Product Change Notice (PCN)

LFPCN0020922

Product Change Notification for Littelfuse FMM75-01F

Littelfuse Lipa part marking example

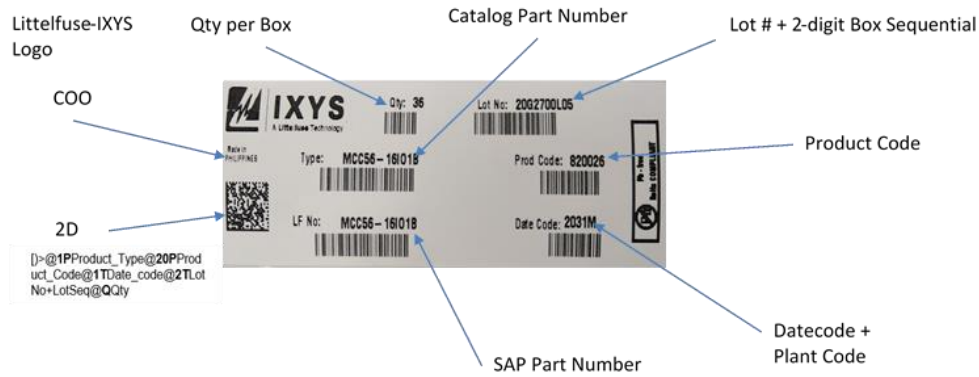
NEW PART MARKING

DESCRIPTION	EXISTING LOCATION	SBU-LIPA
Unit Marking		
Logo		
UL Sign	Yes	Yes
Trademark Sign	Yes	Yes
Part number	Yes	Yes
Date Code	YYWW	YYWW
Assembly Line Code	G	M

NEW SHIPPING LABELS

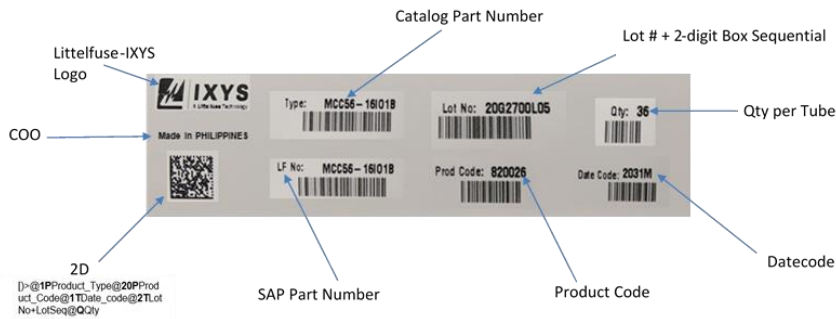
Box label

Tube label

RoHS label
